PCI 2.3 Update Document

This document details the changes between the 2.2 and 2.3 version of the PCI specification. The 2.3 specification changes fall into the following categories:

This document is intended to be an addendum to MindShare's PCI System Architecture book, 4th edition, based on the 2.2 version of the PCI specification. The document is organized in order of occurrence of changes that are associated with the book and the 2.3 specification. The changes described in this document are incorporated into a 5th edition book available only in electronic form. This 5th edition book is in pdf format and can be purchased at http://www.mind-share.com/books/books_main.html. This electronic edition of the book also incorporates the 4th edition errata and ECNs that include:

Figure 3-5: Power, Clock, and Reset Timing

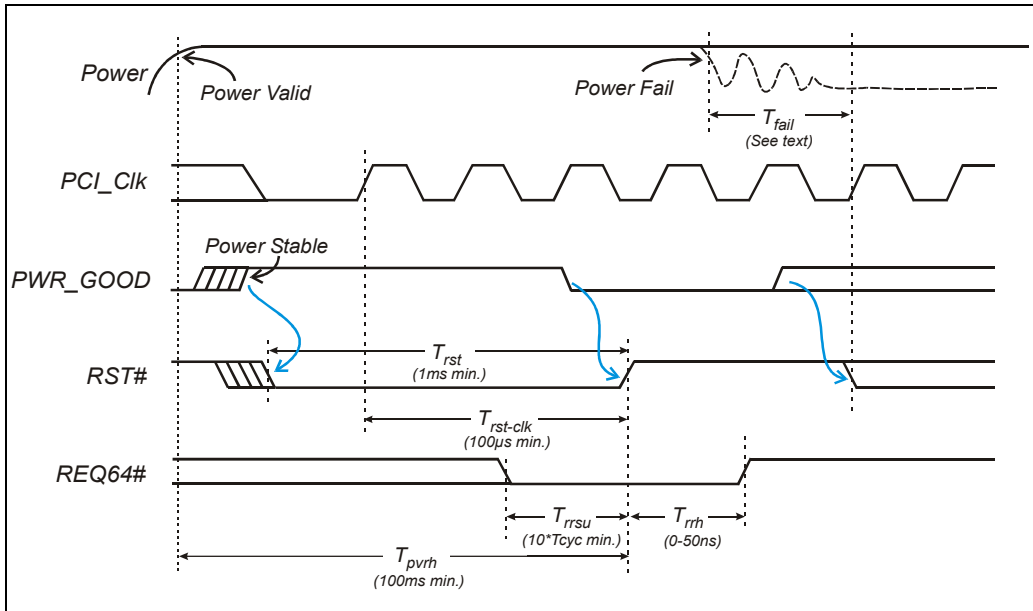
The only change to this section that is brought about by the 2.3 specification is a new parameter defined as "power valid to reset high" timing (Tpvrh). The discussion of this parameter is highlighted in red below and is illustrated in figure 3-5.

- *DURING THE FIRST RESET SEQUENCE (I.E. POWER-UP), RST# MUST REMAIN ASSERTED FOR 100MS FROM POWER VALID (TPVRH). NOTE THAT IF RST# IS ASSERTED WHILE THE POWER SUPPLY VOLTAGES REMAIN WITHIN THEIR SPECIFIED LIMITS (E.G. A SOFTWARE RESET), THE MINIMUM PULSE WIDTH OF RST# IS TRST.*

Figure 4-1: PCI-Compliant Master Device Signals

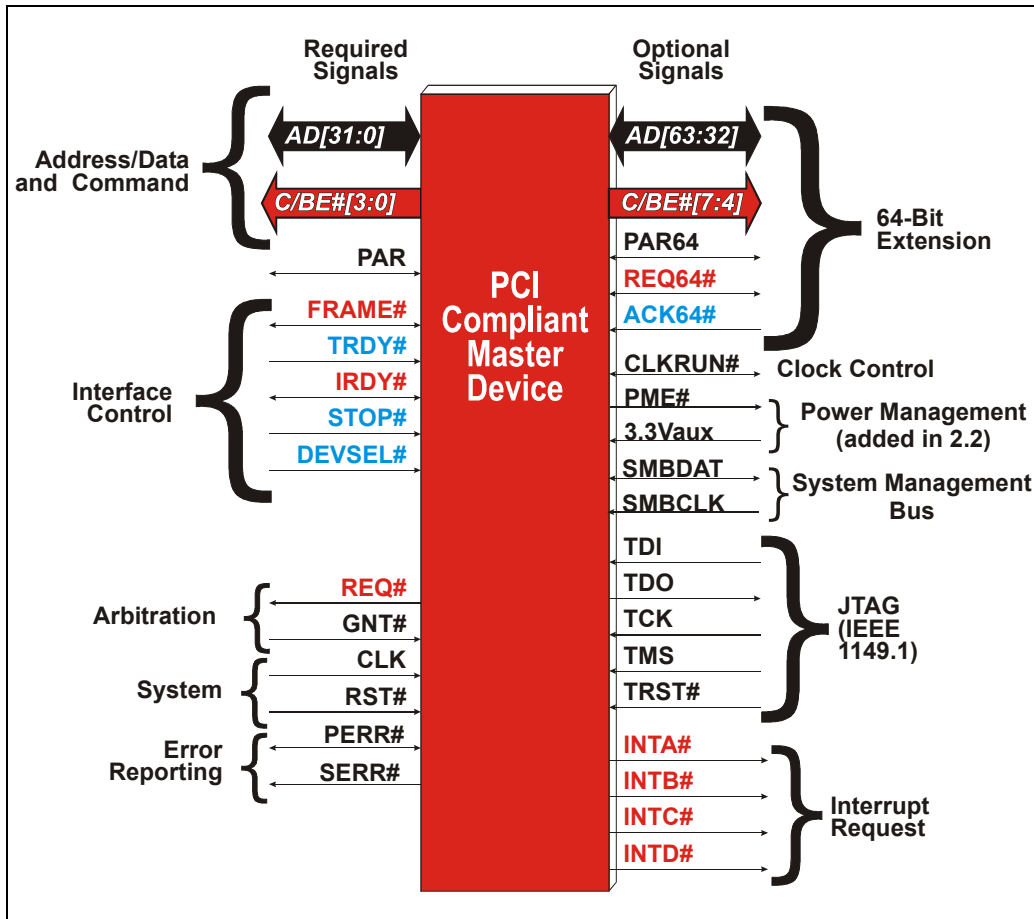
- Figures 4-1 and 4-2 now include the SM Bus interface signals.
- A new section on the SM Bus interface has also been added
- The section on Snoop Support Signals has been removed.
- Table 4-7 now includes the SM Bus signals.

Figure 11-3: Example of *IDSEL* Stepping

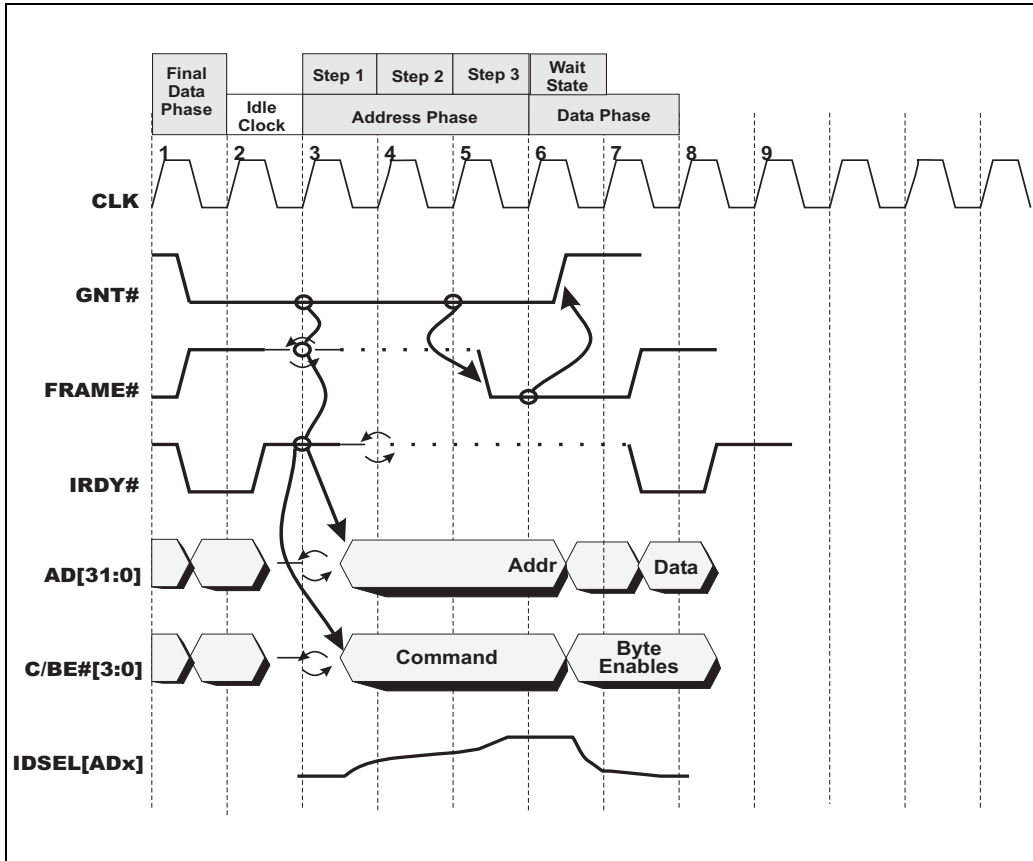
THE 2.3 SPECIFICATION HAS RENAMED ADDRESS/DATA STEPPING TO IDSEL STEPPING. THE NAME CHANGE DENOTES USE OF STEPPING ONLY FOR TYPE ZERO CONFIGURATION TRANSACTIONS. SPECIFICALLY, 2.3 PERMITS THE USE OF STEPPING ON IDSEL PINS WHEN THEY ARE DRIVEN VIA AD SIGNALS THROUGH RESISTIVELY-COUPLED CONNECTIONS.

FIGURE 11-3 ON PAGE 11 PROVIDES AN EXAMPLE OF AN INITIATOR USING STEPPING OVER A PERIOD OF THREE CLOCKS TO DRIVE THE ADDRESS ONTO THE AD BUS.

Figure 14-4: Interrupt Disable Bit Added to Configuration Command Register

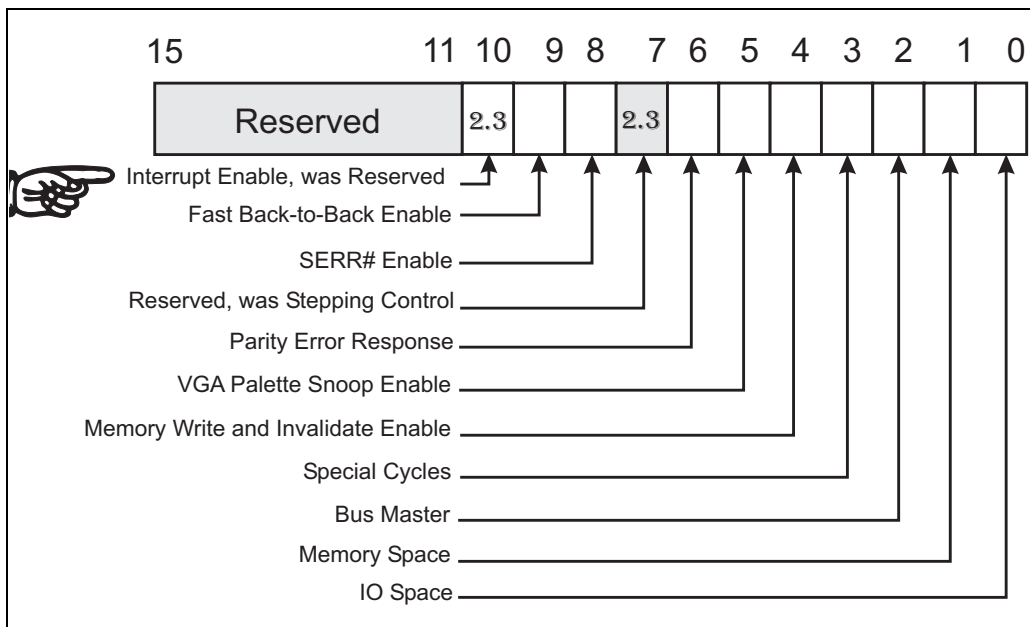
THE 2.3 SPECIFICATION ADDED AN INTERRUPT DISABLE BIT (BIT 10) TO THE CONFIGURATION COMMAND REGISTER. SEE FIGURE 14-4 ON PAGE 12. THE BIT IS CLEARED AT RESET PERMITTING GENERATION OF INTX SIGNAL GENERATION. SOFTWARE MAY SET THIS BIT THEREBY INHIBITING GENERATION OF INTERRUPTS VIA THE INTX SIGNALS. NOTE THAT THE INTERRUPT DISABLE BIT HAS NO EFFECT ON MESSAGE SIGNALLED INTERRUPTS (MSI). THESE INTERRUPTS ARE ENABLED VIA THE MSI CAPABILITY COMMAND REGISTER.

Figure 14-5: Interrupt Status Bit Added to PCI Configuration Status Register

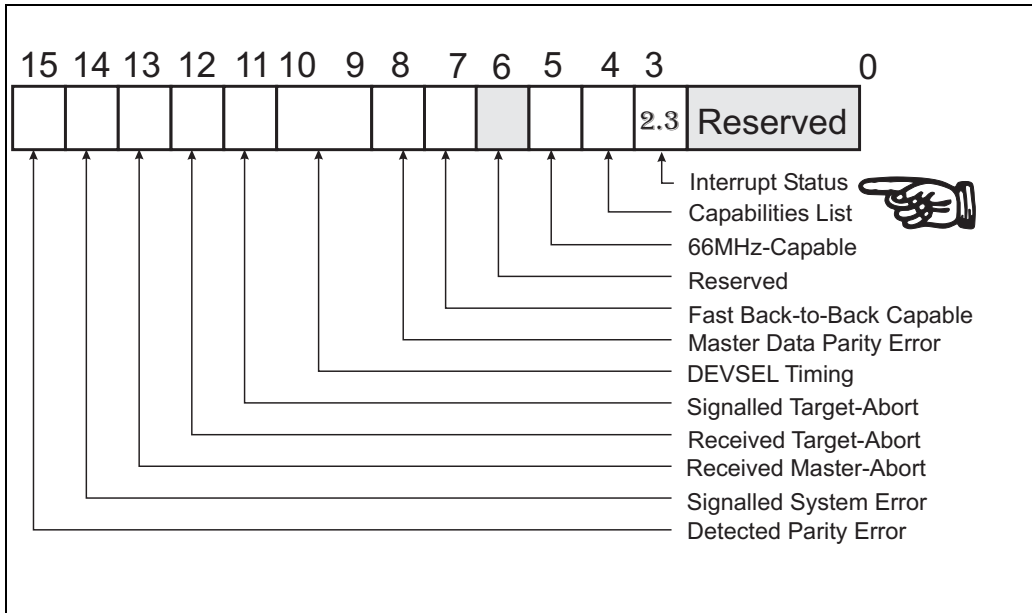
THE 2.3 SPECIFICATION ADDED AN INTERRUPT STATUS BIT TO THE CONFIGURATION STATUS REGISTER (PICTURED IN FIGURE 14-5 ON PAGE 14). A FUNCTION MUST SET THIS STATUS BIT WHEN AN INTERRUPT IS PENDING. IN ADDITION, IF THE INTERRUPT DISABLE BIT IN THE CONFIGURATION COMMAND REGISTER IS CLEARED (I.E. INTERRUPTS ENABLED), THEN THE FUNCTION'S INTx# SIGNAL IS ASSERTED, BUT ONLY AFTER THE STATUS BIT IS SET. THIS BIT IS UNAFFECTED BY THE STATE OF THE INTERRUPT DISABLE BIT, AND THIS BIT HAS NO AFFECT ON THE MSI MECHANISM.

Figure 19-3: Command Register Bit Assignment

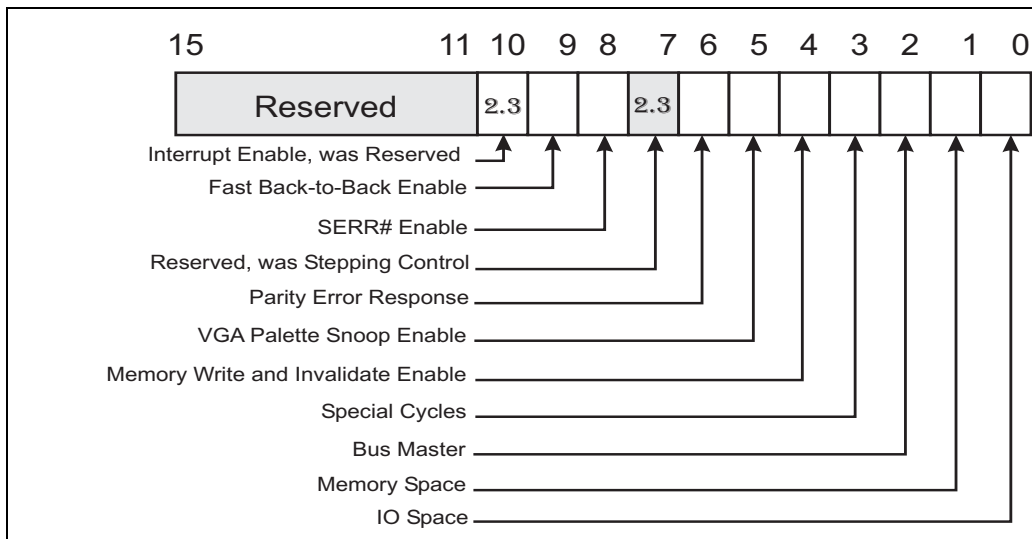
- Bit 7, previously defined as Stepping Control is now Reserved.
- Bit 10, previously Reserved is now defined as Interrupt Disable.

Table 19-21 on page 18 pictures the bits that have changed with the introduction of the PCI 2.3 specification and the register is illustrated in Figure 19-3 on page 17.

Figure 19-4: Status Register Bit Assignment

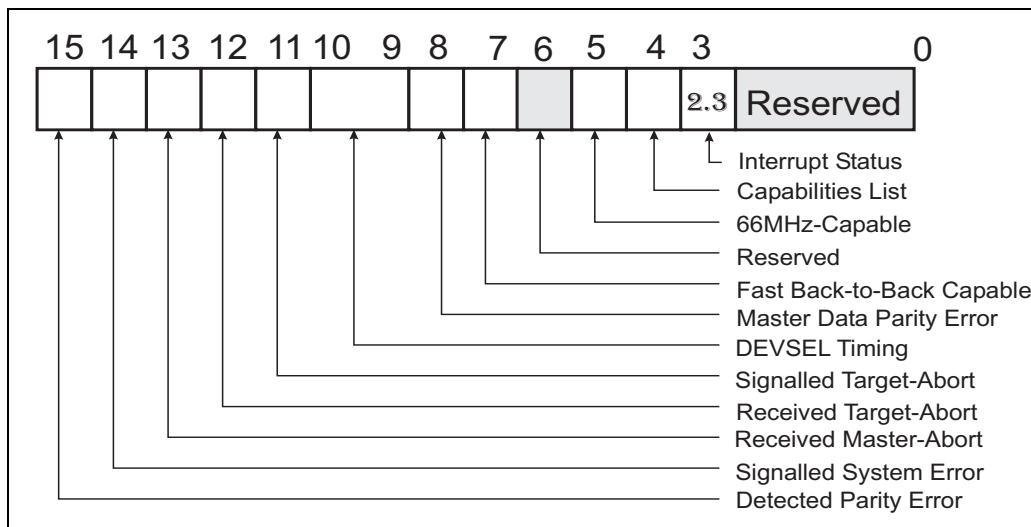
Figure 19-4 pictures the Status Register and Table 19-22 on page 19 describes the Status register bit that has been added by the PCI 2.3 spec.

Figure 21-3: 3.3V, and Universal Card (5V Only Cards Not Support by Ver. 2.3)

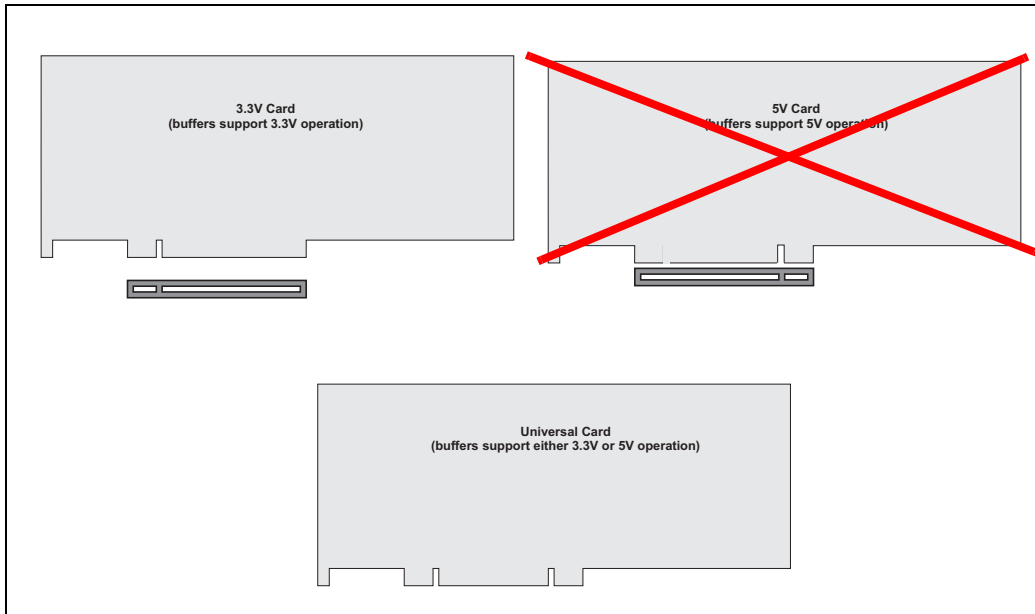
- ELIMINATION OF THE 5 VOLT ONLY CARD — TO PUSH THE MIGRATION FROM 5V-ONLY IMPLEMENTATIONS TO OR 3.3V OR UNIVERSAL CARD IMPLEMENTATIONS. NOTE THAT THIS DOES NOT AFFECT 5V CONNECTORS.
- ADDITION OF TWO NEW PINS TO SUPPORT THE SYSTEM MANAGEMENT BUS IN PCI.

Figure 21-3 on page 21 illustrates the change in support for 5V only cards that only the Universal card provides 5V connector compatibility.
